Site Address: British Museum Archaeological Research Collection (Arc) Facility,
Land Off Cutbush Lane, Shinfield, RG2 9AA

Proposal: Full application for the proposed creation of a secondary vehicular access with associated landscaping, gates and fencing, plus removal of existing hardstanding and relocation of a shelter.

MEMORANDUM

Visibility Splays

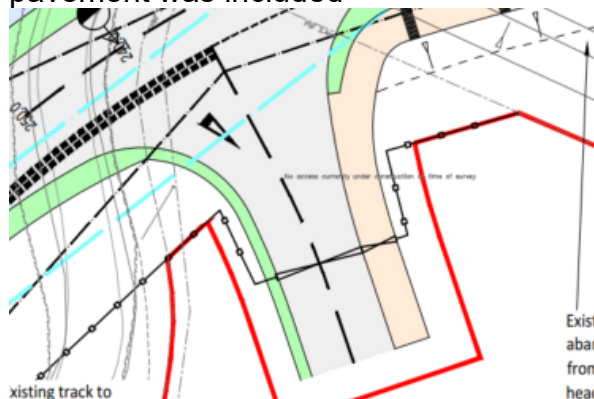
10. Visibility splays of 2.4m x 74m have been submitted this is acceptable.
